Document 009113.1.1 - Addendum No. 1

DeKalb County, Illinois
Courthouse Addition
Bid Package 1

PSA-Dewberry No.: 50038973

Sketch No.:
SSK-01

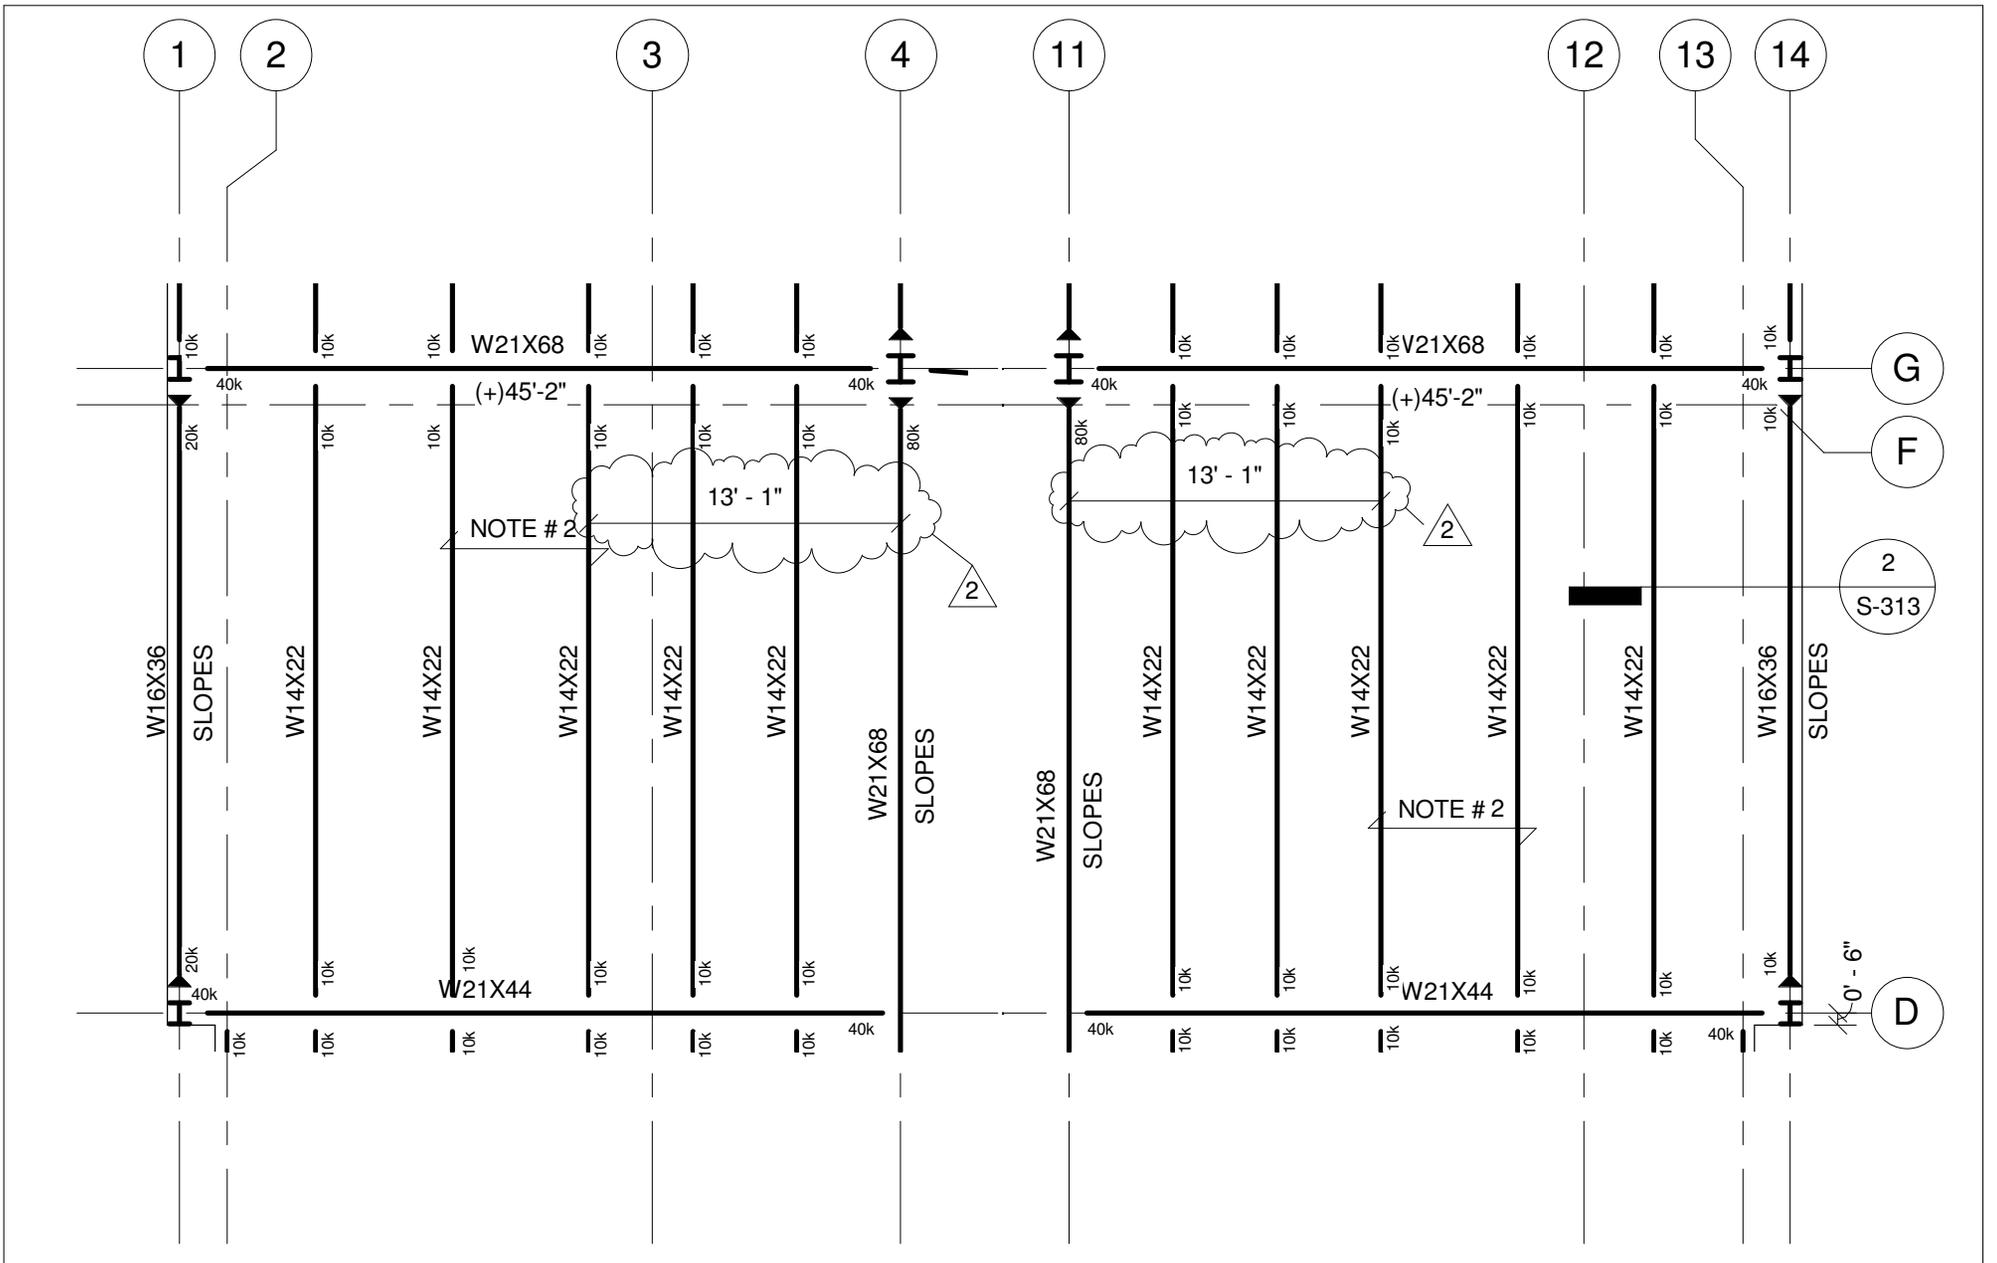
1. REVERSE section cut view direction for details 1/S-310, 2/S-310 and 4/S-310.
2. REVISE plan note #10 to read as follows: "2 1/16" LIGHTWEIGHT CONCRETE WITH 6x6-W1.4Xw1.4 WWF ON 15/16", 20ga. METAL FORM DECK (3" TOTAL SYSTEM). SEE GENERAL STRUCTURAL NOTES FOR DECK ATTACHMENT."
3. ADD dimensions locating beam framing as shown in the attached sketch SSK-01.

Subject:
DIMENSION BEAM FRAMING

Sketch No.:
 SSK-02

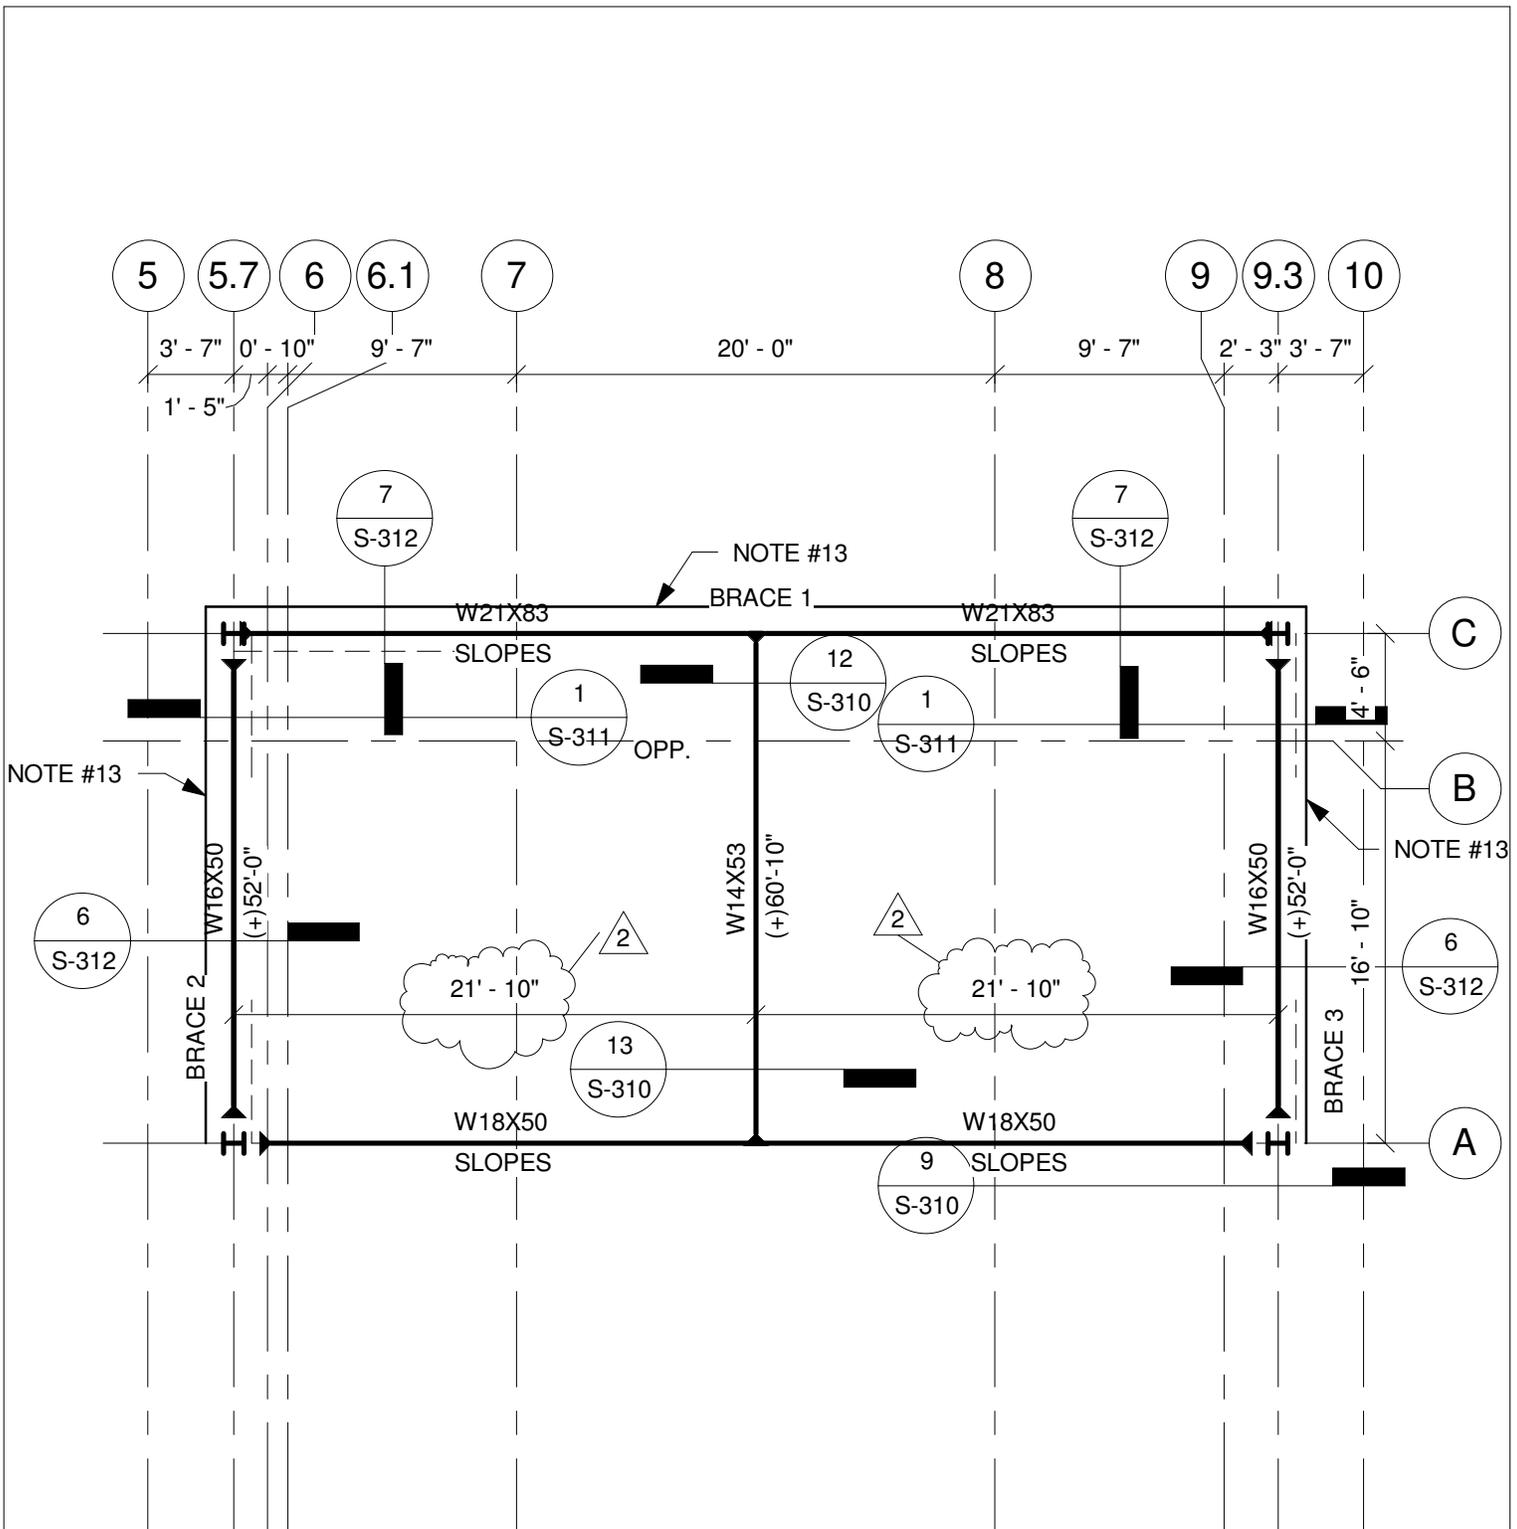
1. CLARIFY beam locations as shown in the attached sketches SSK-02 and SSK-03.
2. ADD plan note #15 as follows: "SEE SHEET S-420 FOR BRACING ELEVATIONS 1 THRU 3 AND DETAILS."
3. CLARIFY top of steel from W16x16 beams on line H is (+)46'-0".

PSA Dewberry PSA DEWBERRY 25 S. GROVE AVE., SUITE 500 ELGIN, IL 60120 (847) 695 5840 (847) 742 4571 Fax	REVISE DECK ANGLE	Date: 01-04-11	Issued As: ADD. #1 -BP#1	Sketch No.: SSK-04
	Project: DEKALB COUNTY COURTHOUSE ADDITION	Scale: AS INDICATED	Project No.: 50038973	Drawing Reference No.: 1/S-200

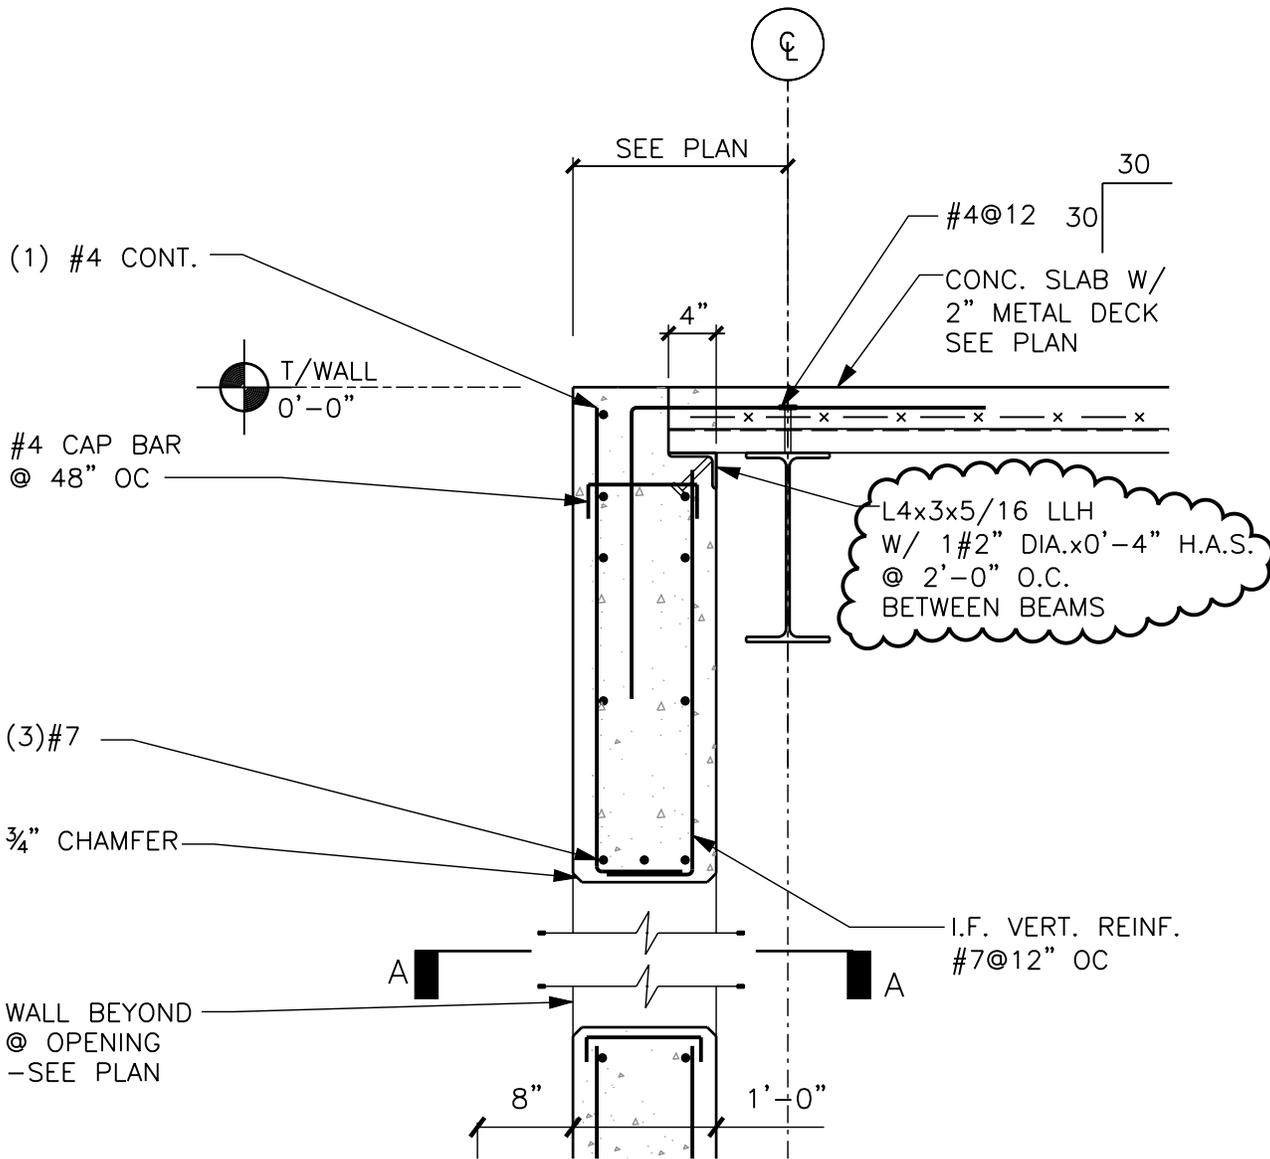
1. REVISE deck support angle as shown in the attached sketch SSK-04.

PROVIDE ANGLE BETWEEN BEAMS

SSK-05

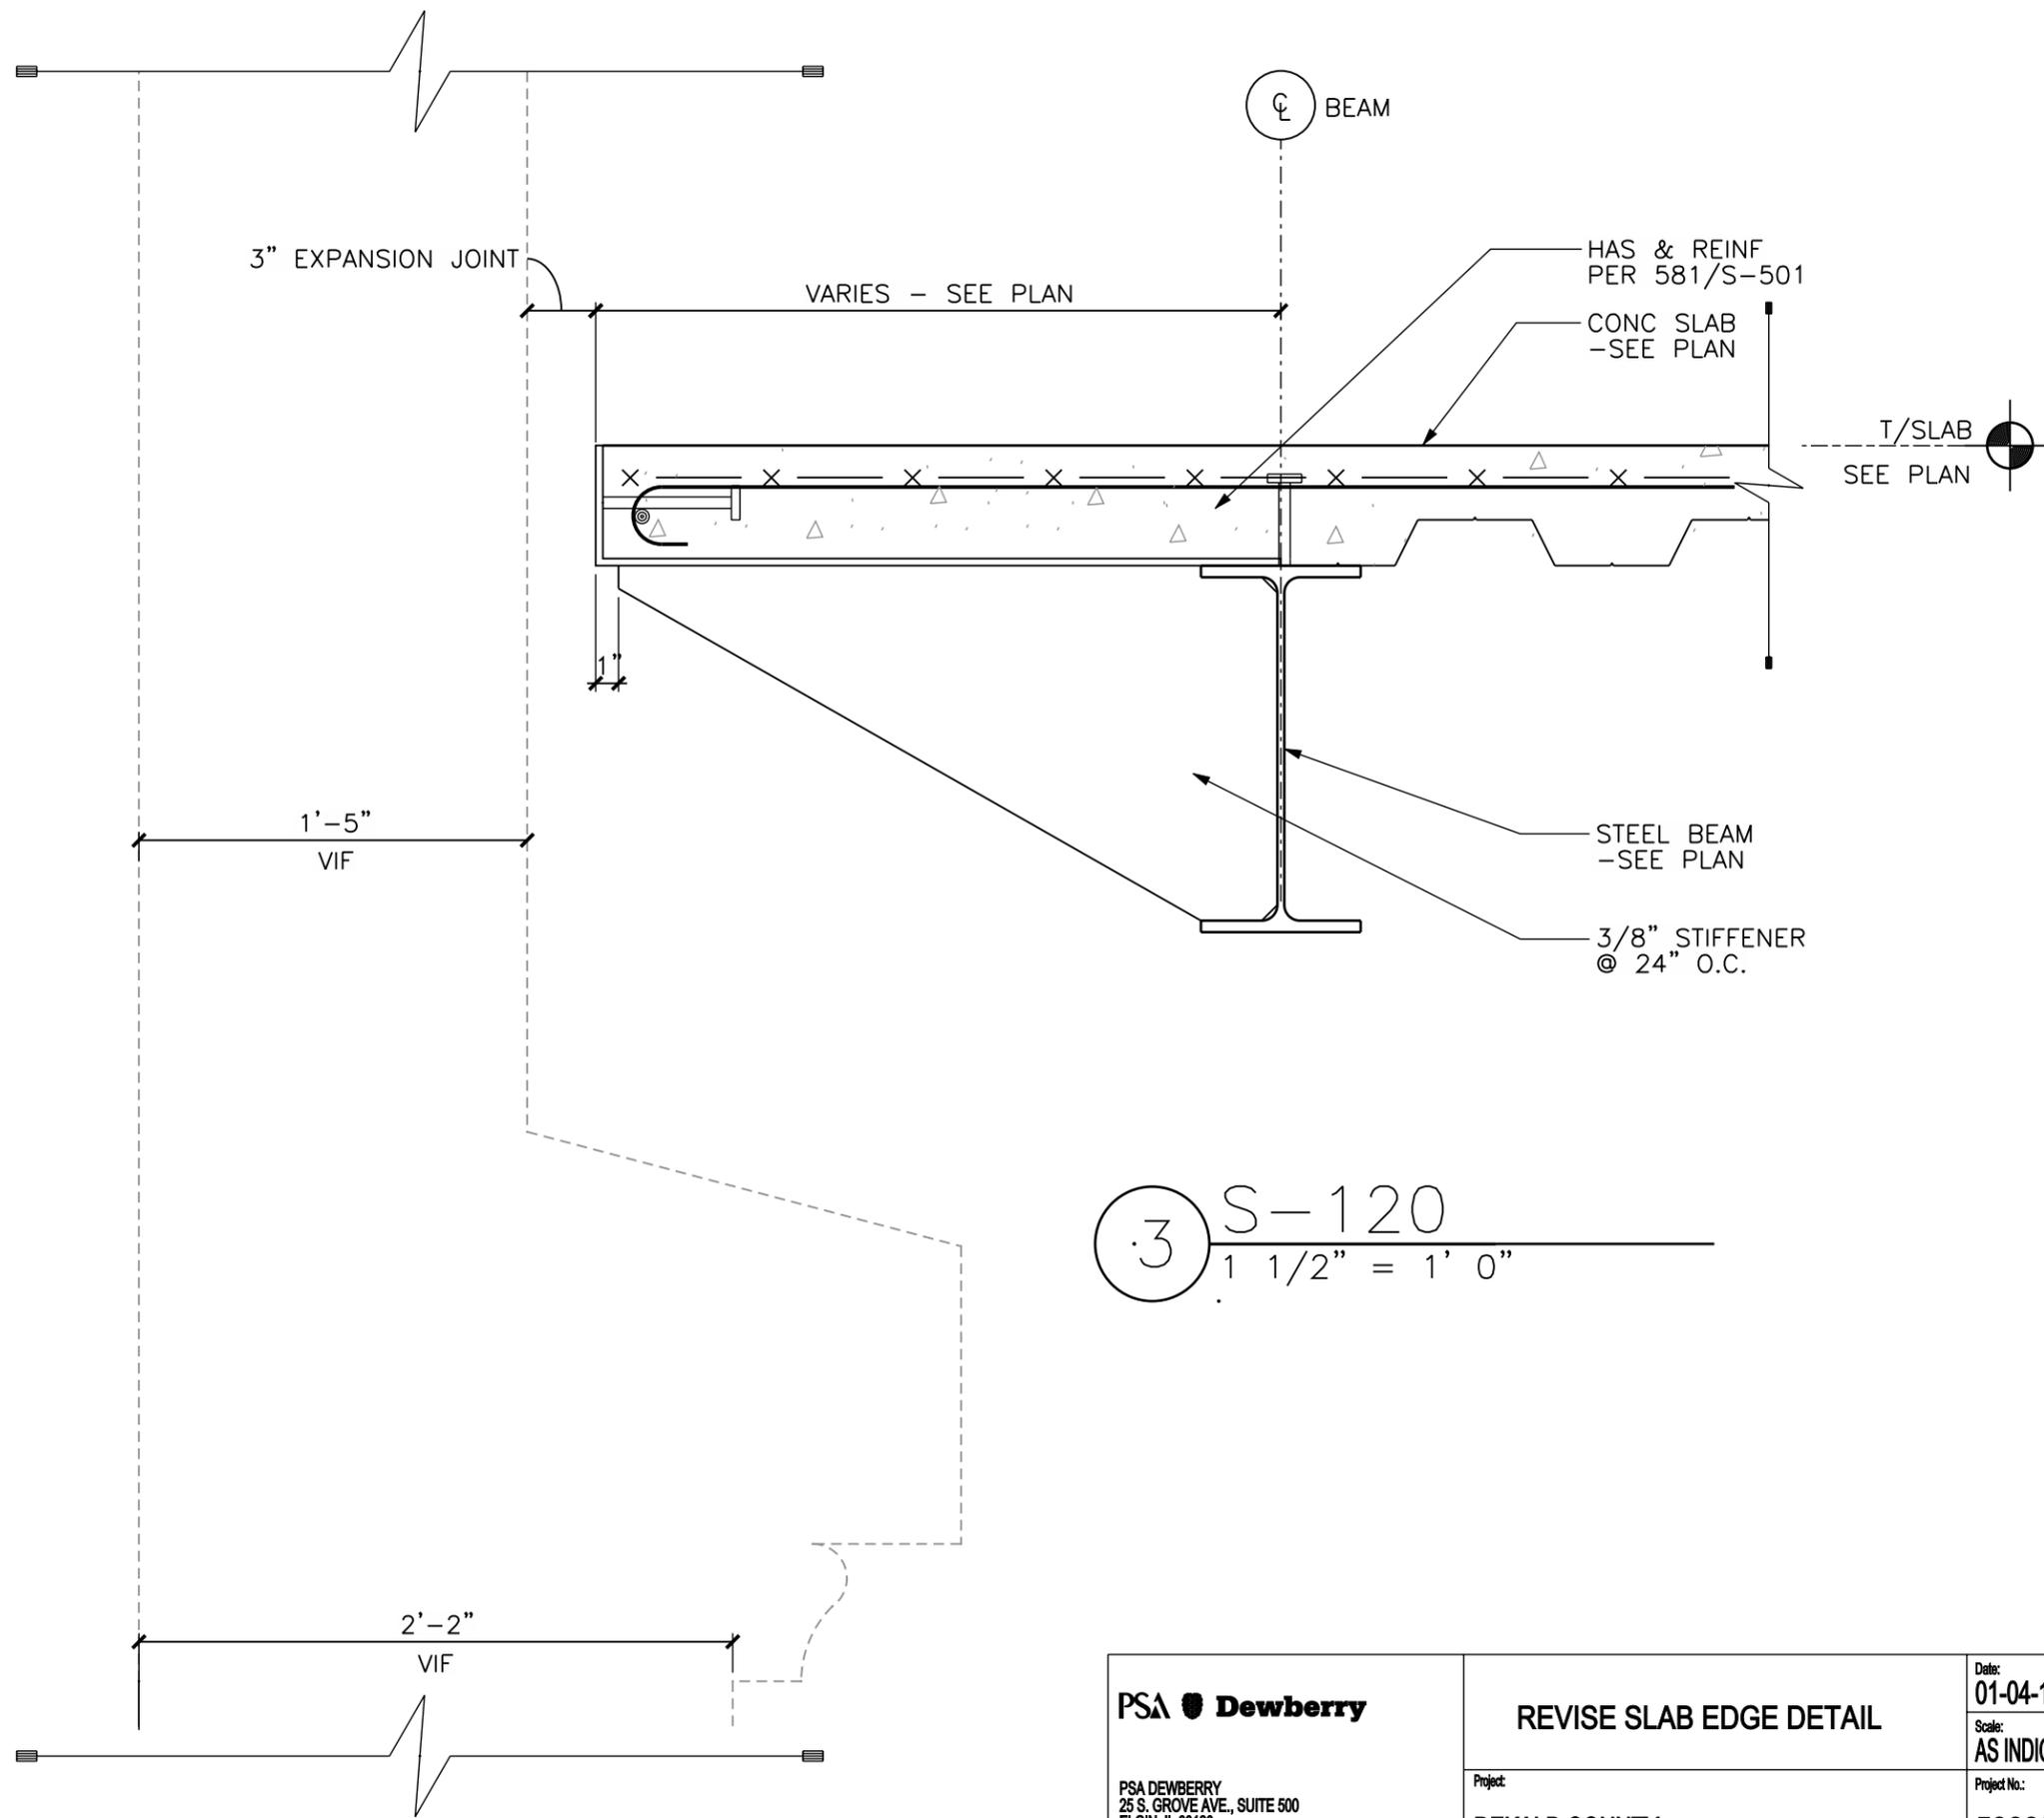
1. REVISE deck support angle as shown in the attached sketch SSK-05.
